RESOLUTION MSC.125(75)
(adopted on 24 May 2002)

**ADOPTION OF AMENDMENTS TO THE GUIDELINES ON THE ENHANCED
PROGRAMME OF INSPECTIONS DURING SURVEYS OF BULK CARRIERS AND
OIL TANKERS (RESOLUTION A.744(18), AS AMENDED)**

**AMENDMENTS TO THE GUIDELINES ON THE ENHANCED PROGRAMME OF
INSPECTIONS DURING SURVEYS OF BULK CARRIERS AND OIL TANKERS
(RESOLUTION A.744(18), AS AMENDED)**

“Appendix 4

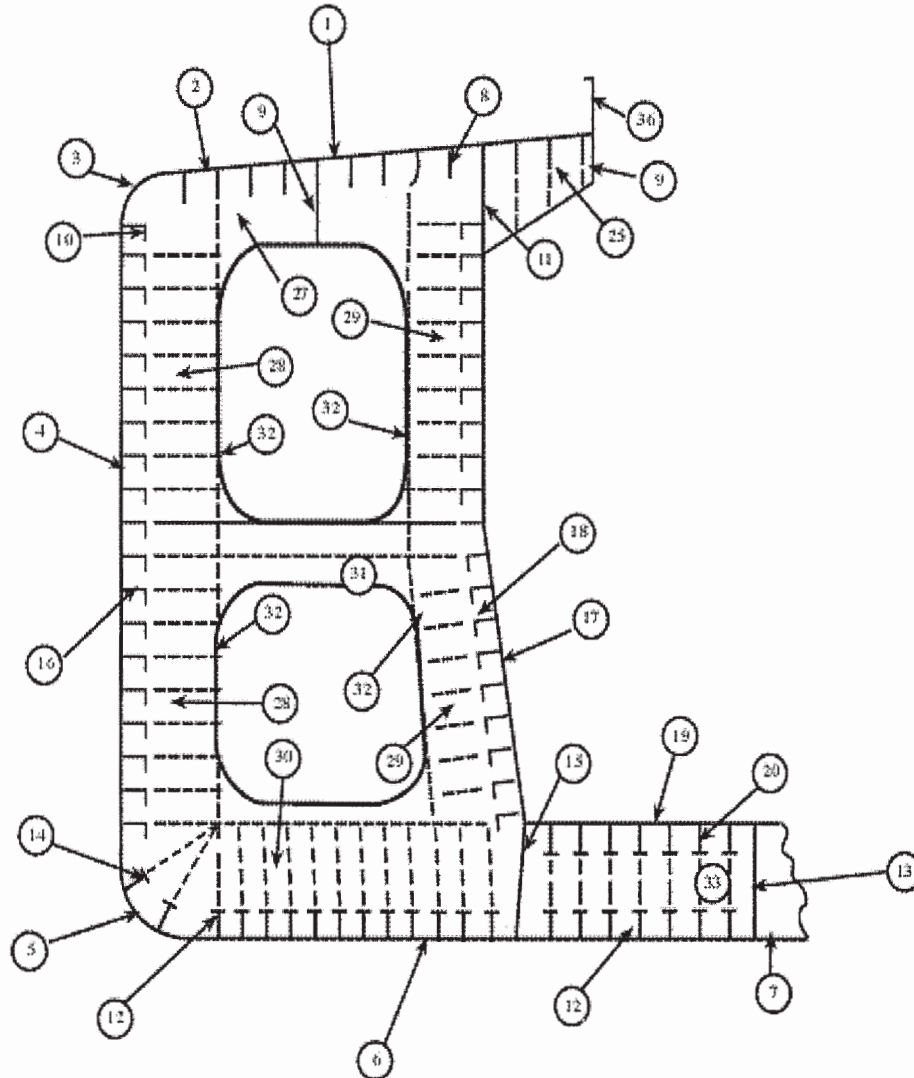
14 In annex 8, the following new appendices 4 and 5 are added after appendix 3:

Thickness measurement and typical transverse section indicating longitudinal and transverse members

Report on TM2-BC (1) and (2)	
1.	Strength deck plating
2.	Stringer plate
3.	Sheerstrake
4.	Side shell plating
5.	Bilge plating
6.	Bottom shell plating
7.	Keel plate

Report on TM6-BC	
36.	Hatch coamings
37.	Deck plating between hatches
38.	Hatch covers

Report on TM3-BC	
8.	Deck longitudinals
9.	Deck girders
10.	Sheerstrake longitudinals
11.	Longitudinal bulkhead top strake
12.	Bottom longitudinals
13.	Bottom girders
14.	Bilge longitudinals
15.	Longitudinal bulkhead lower strake
16.	Side shell longitudinals
17.	Longitudinal bulkhead plating (remainder)
18.	Longitudinal bulkhead longitudinals
19.	Inner bottom plating
20.	Inner bottom longitudinals

Report on TM4-BC	
25.	Deck transverse centre tank
26.	Bottom transverse centre tank
27.	Deck transverse wing tank
28.	Side shell vertical web
29.	Longitudinal bulk-head vertical web
30.	Bottom transverse wing tank
31.	Struts
32.	Transverse web face plate
33.	D.b. floors

Appendix 5

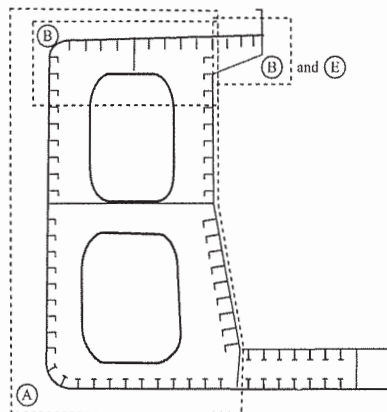
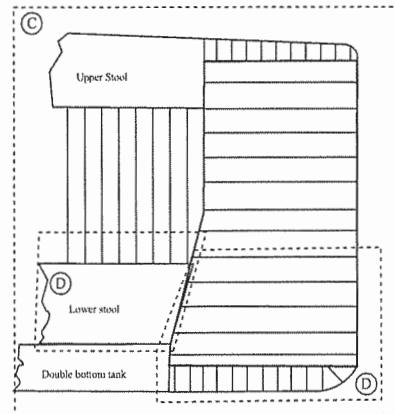
Ore carriers Thickness measurement and close-up survey requirements

Typical transverse section close-up survey

Thickness to be reported on
TM3-T of Annex B and TM4-T of Annex B
as appropriate

Close-up survey
area

Typical transverse bulkhead

Thickness to be reported on TM5-T of Annex B

Figure 1. Ships without lower stool

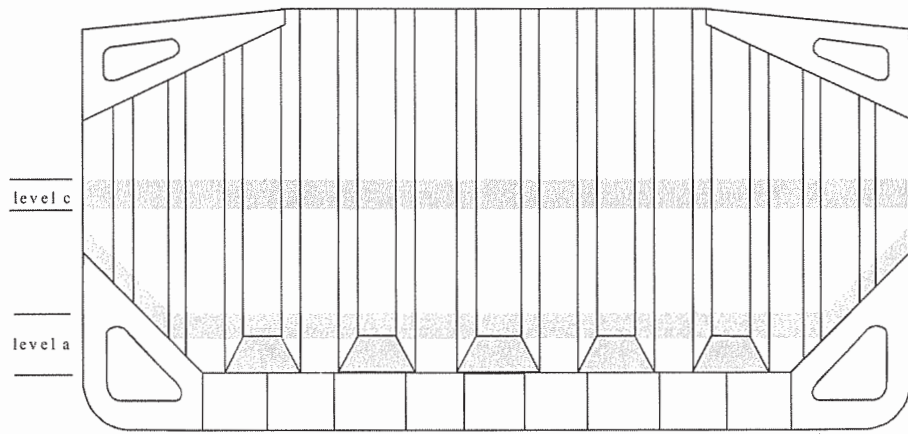
Level (a) Ships without lower stool (see figure 1):

- The mid-breadth of the corrugation flanges at approximately 200 mm above the line of shedder plates;
- The middle of gusset plates between corrugation flanges, where fitted;
- The middle of the shedder plates;
- The mid-breadth of the corrugation webs at approximately 200 mm above the line of shedder plates.

Level (c) Ships with or without lower stool (see figures 1 and 2):

- The mid-breadth of the corrugation flanges and webs at about the mid-height of the corrugation.

Figure 2. Ships with lower stool

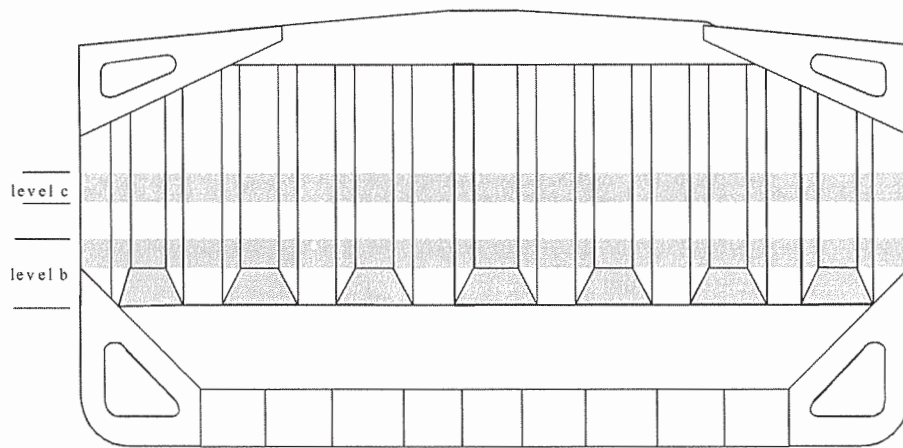
Level (b) Ships with lower stool (see figure 2):

- The mid-breadth of the corrugation flanges at approximately 200 mm above the line of shedder plates;
- The middle of gusset plates between corrugation flanges, where fitted;
- The middle of the shedder plates;
- The mid-breadth of the corrugation webs at approximately 200 mm above the line of shedder plates.
